**RFB-2024-65**  
**SUNY SCCC CST BUILDING LOBBY AND BATHROOM RENOVATIONS**  
**C2 DESIGN GROUP**

**ADDENDUM #1**

Issued Date: 12/5/2024

**4** Roof Edge Detail  
 A104 SCALE: 1 1/2" = 1'-0"

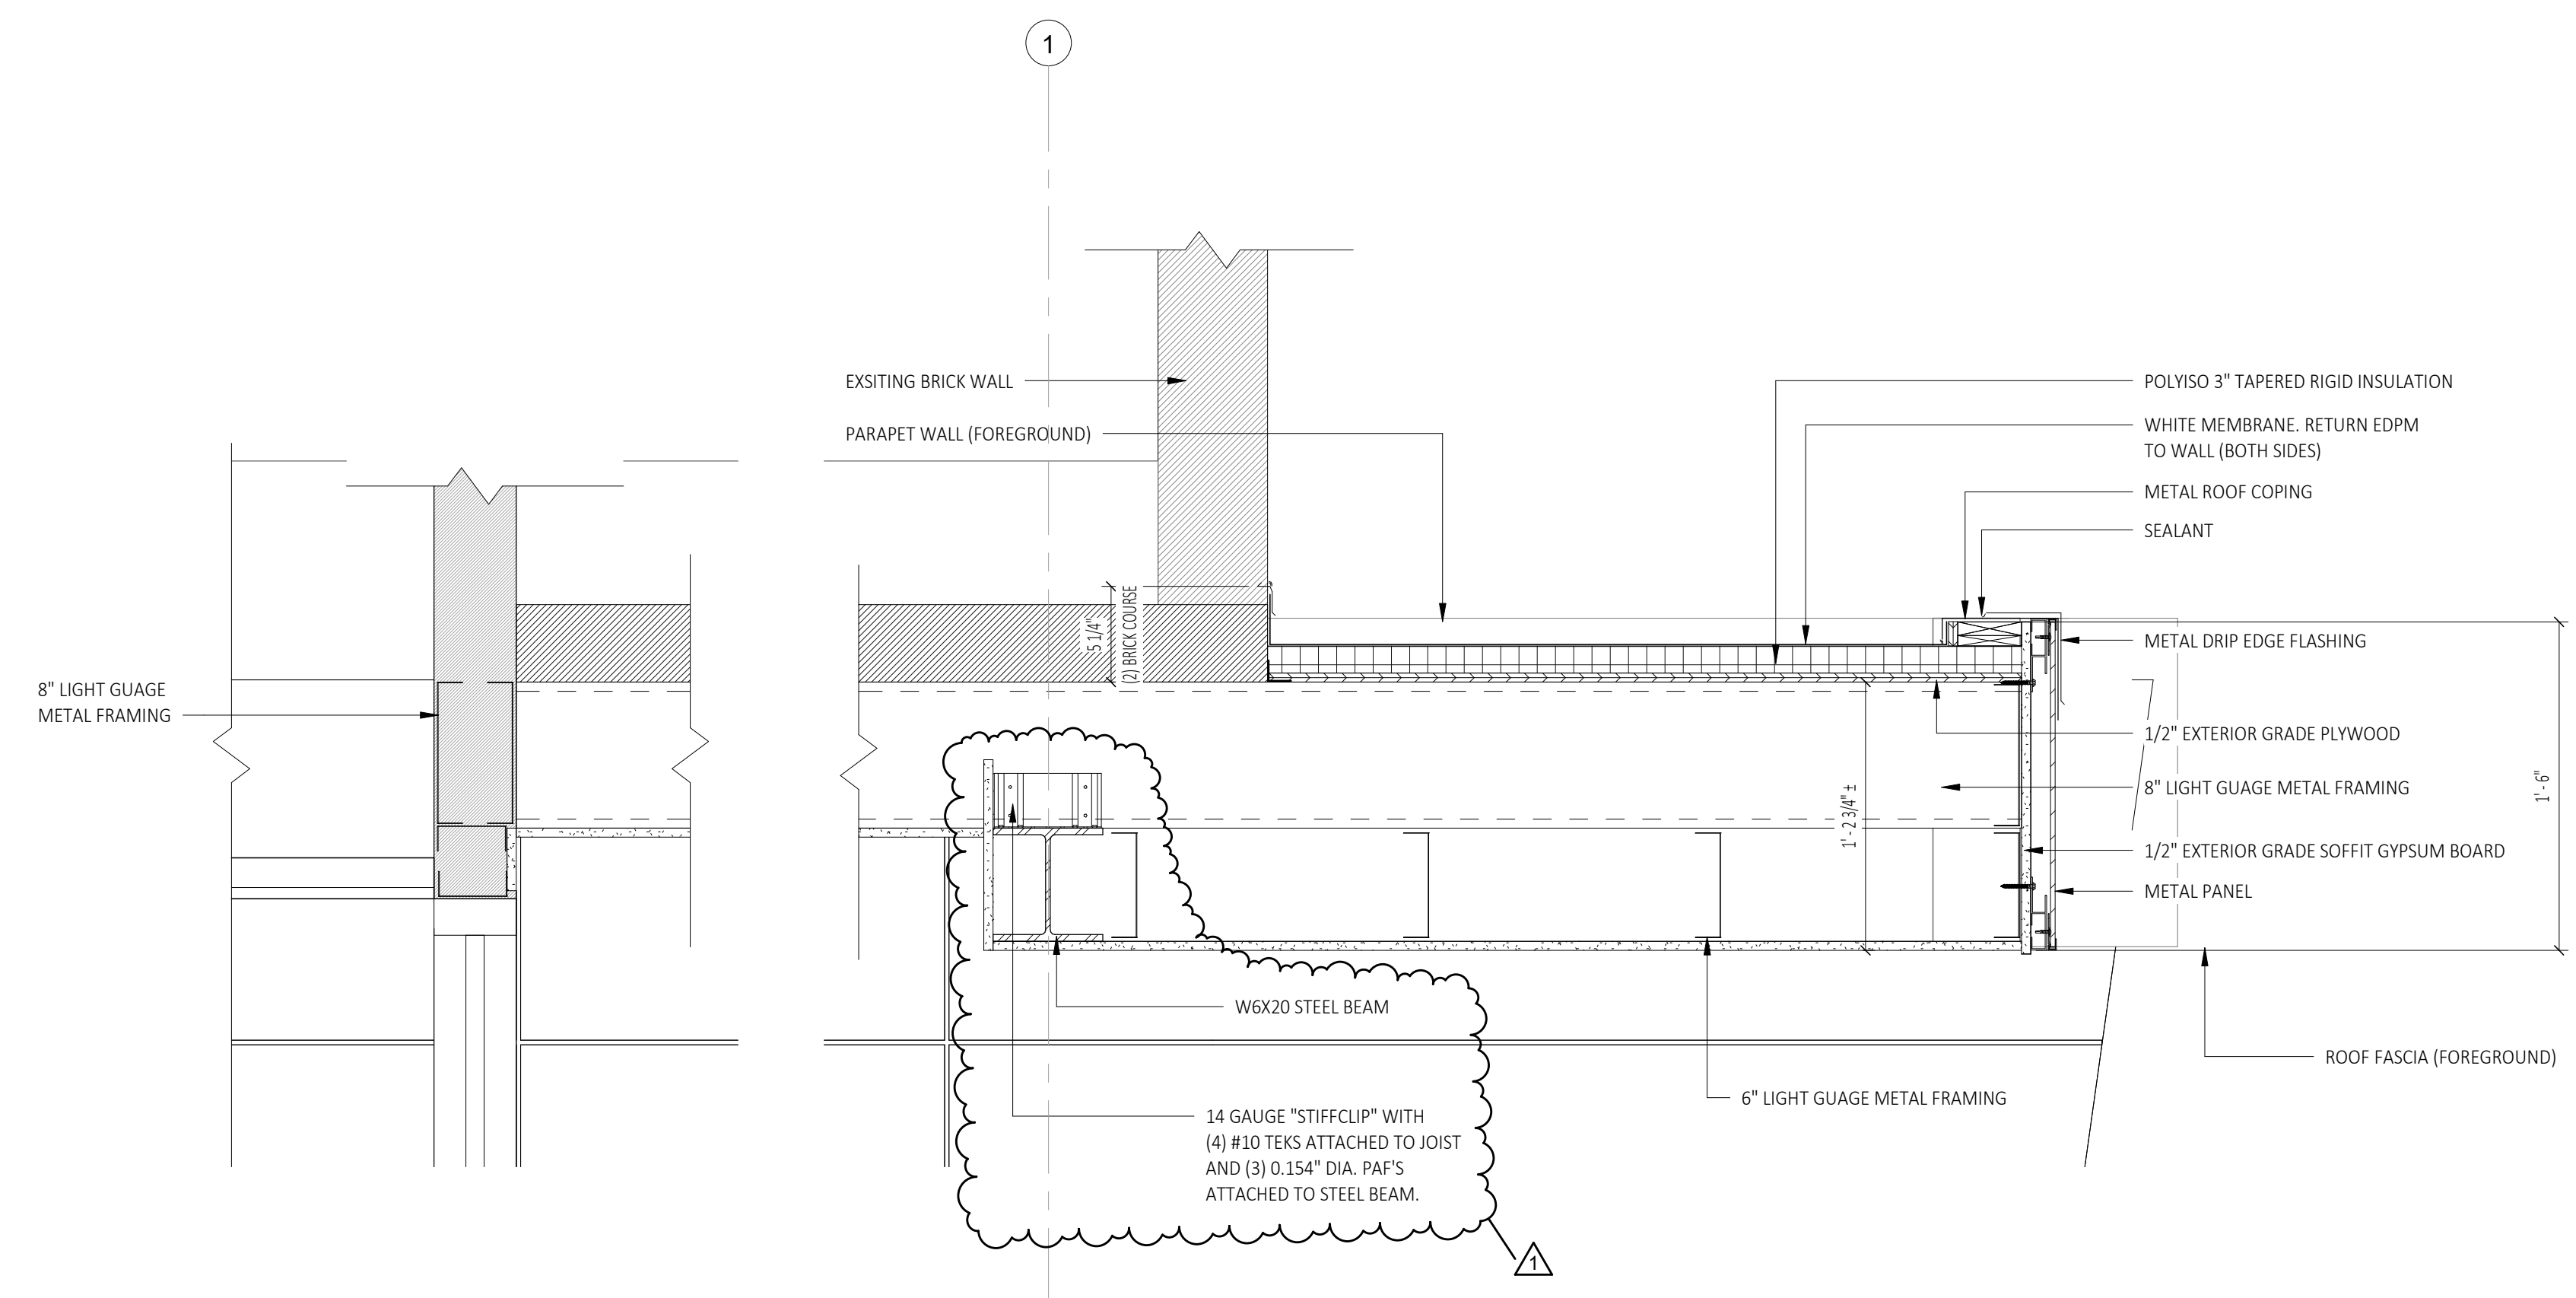
5. Drawing A104 – Roof Plan and Details
  - a. Revisions as marked Addendum #1
6. Drawing A200 – Building Elevations
  - a. Revisions as marked Addendum #1
7. Drawing A400 – Stair Sections
  - a. Revisions as marked Addendum #1
8. Drawing A500 – Exterior Details
  - a. Revisions as marked Addendum #1
9. Drawing A701 – Interior Elevations
  - a. Revisions as marked Addendum #1
10. Drawing A900 – Schedules
  - a. Revisions as marked Addendum #1
11. Specifications 08 41 13 – Aluminum Storefront Systems
12. Specifications 08 71 00 – Door Hardware

**A200**

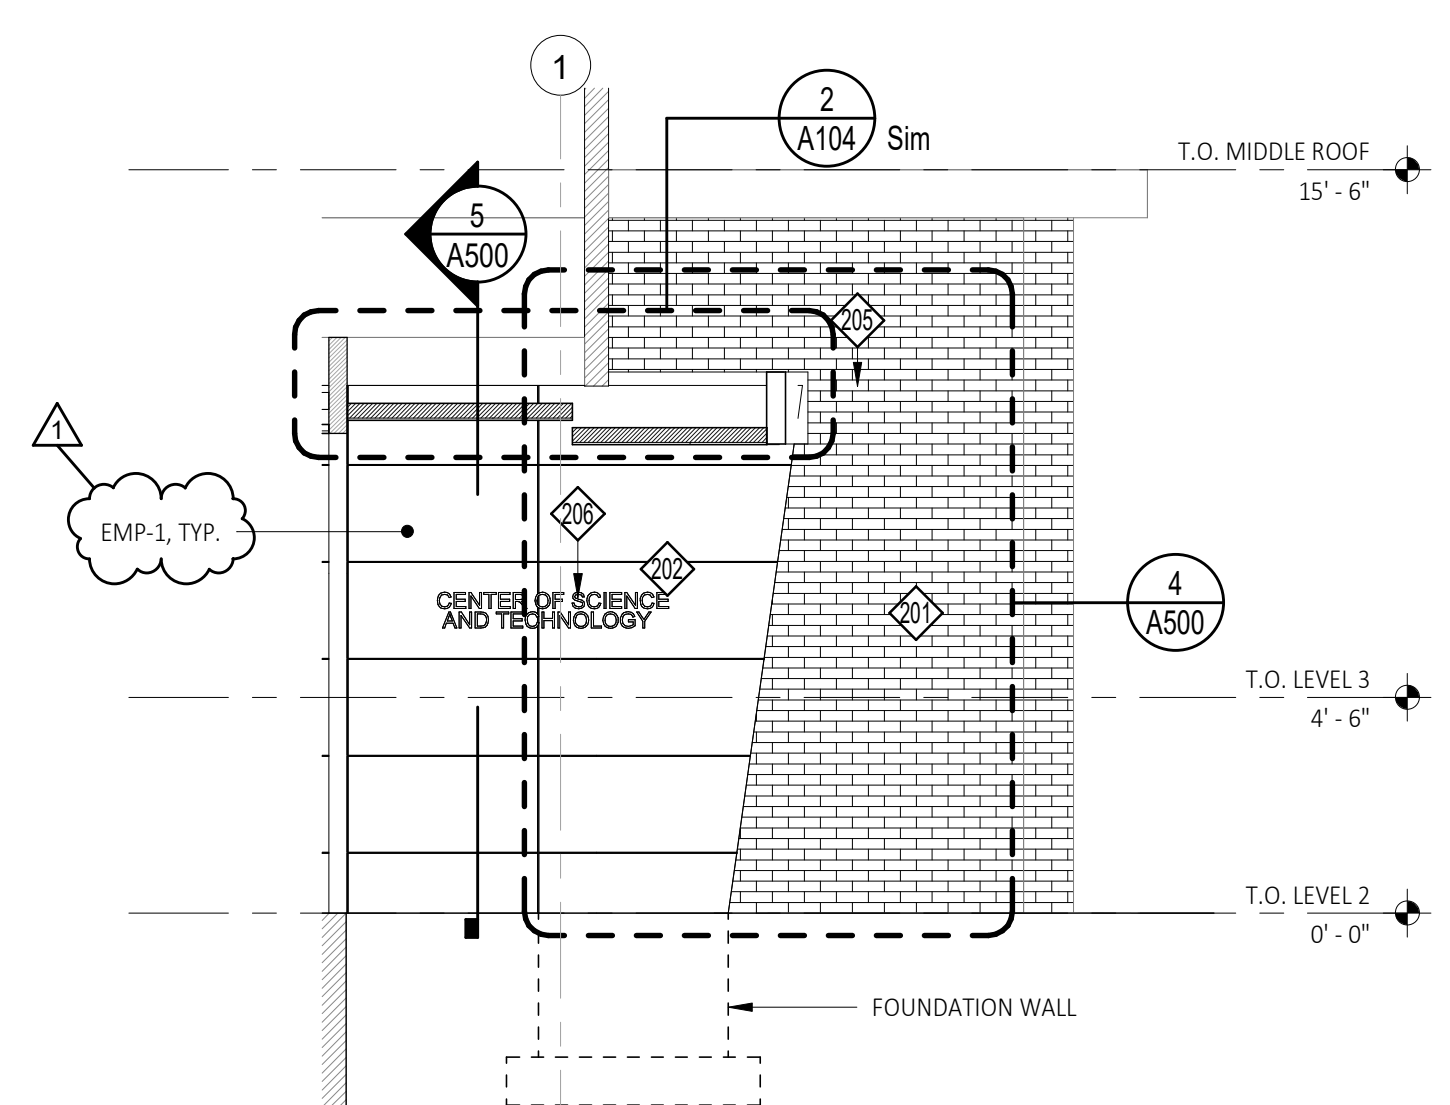
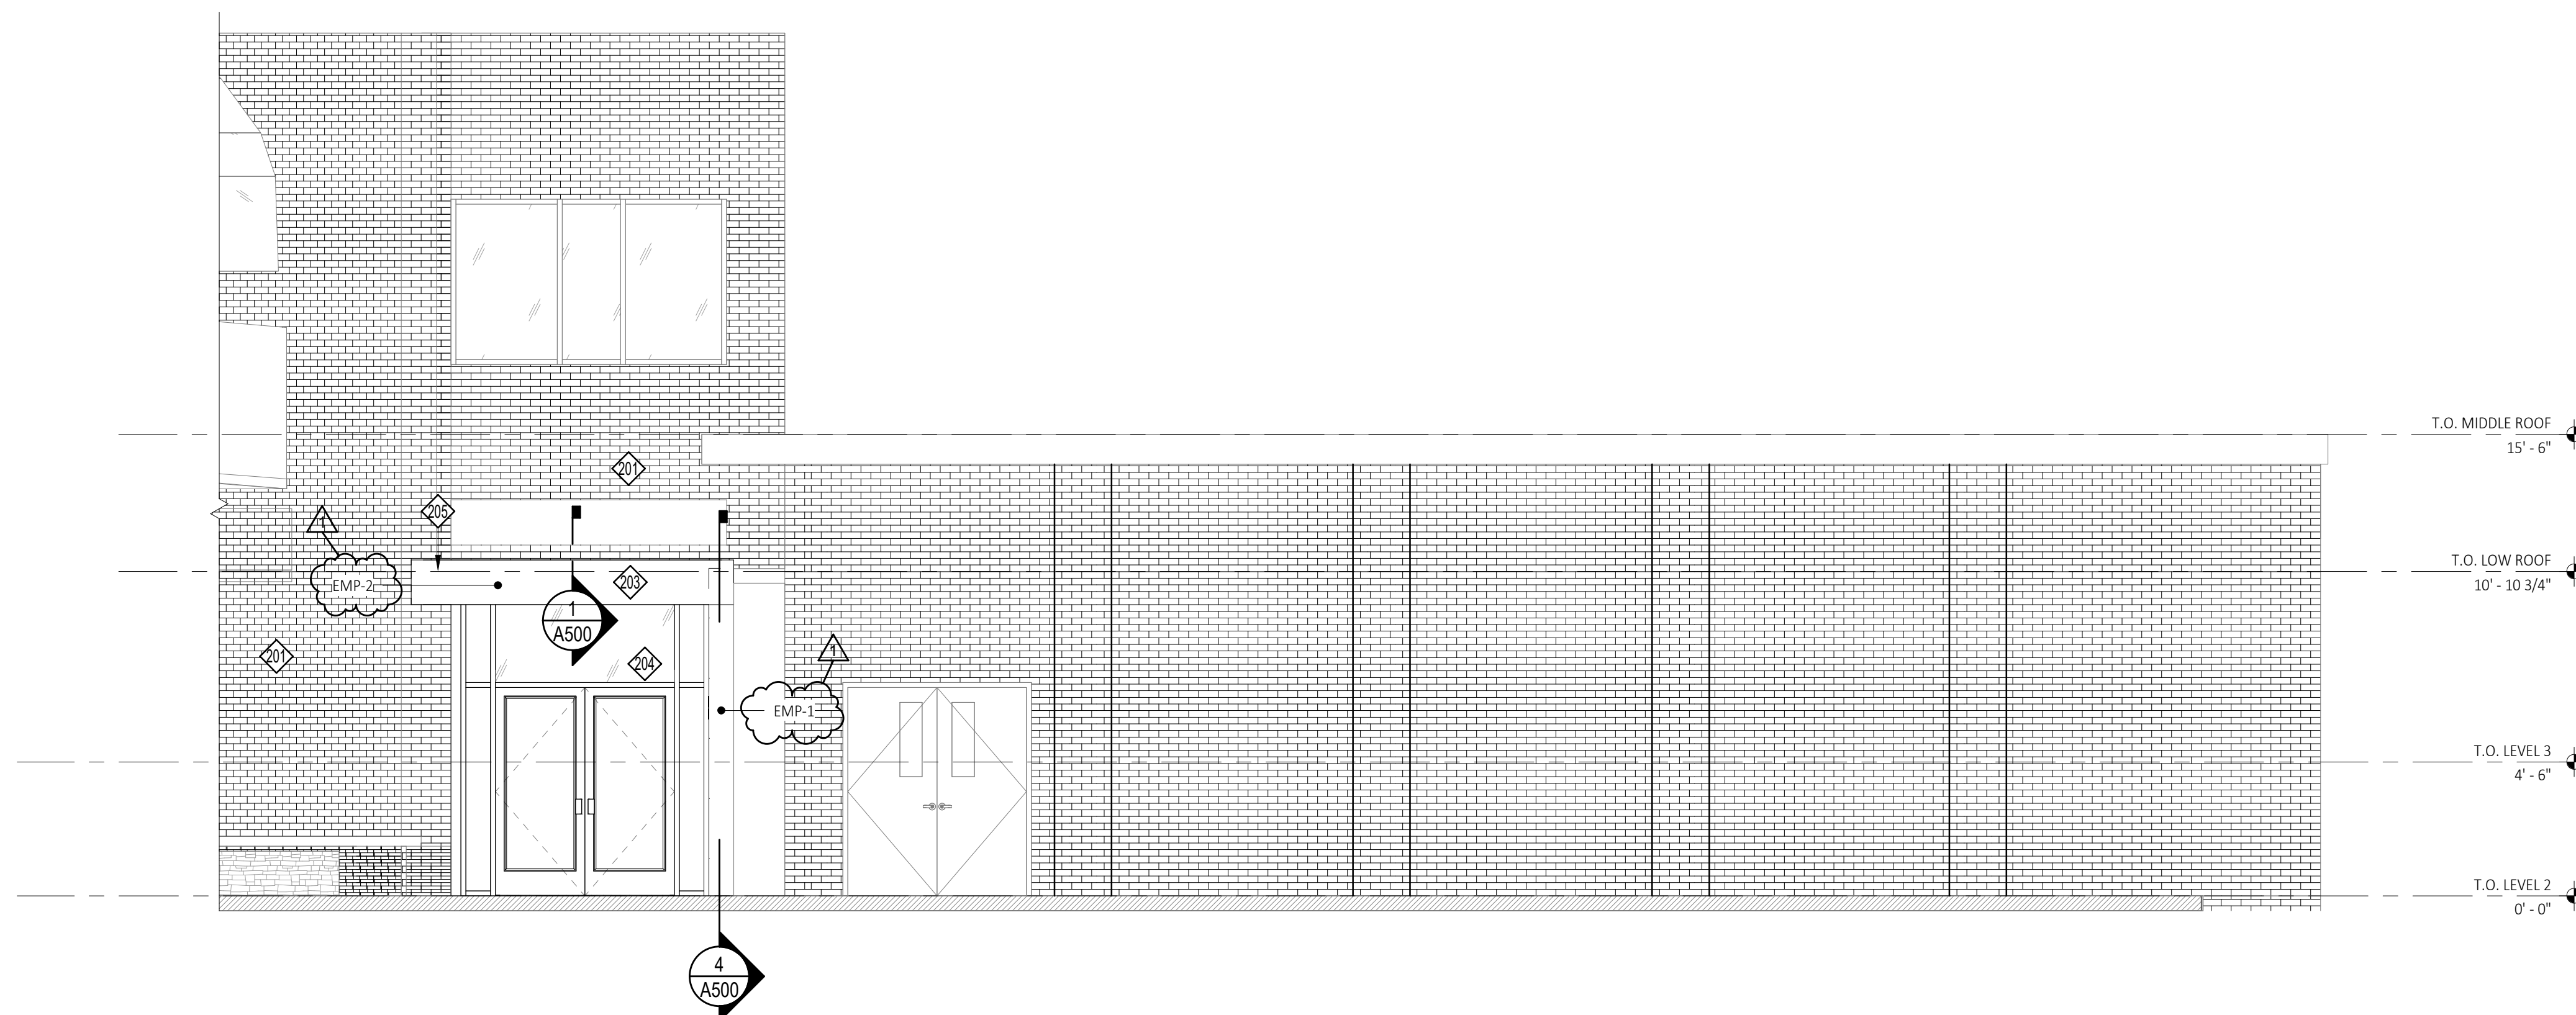
1. Drawing A901, Finish legend calls out two different Types for exterior metal wall panels (EMP-1 & EMP-2) but the drawing only shows “metal panel”. Please clarify?
  - a. Response: See Drawings A200 & A701 Addendum#1
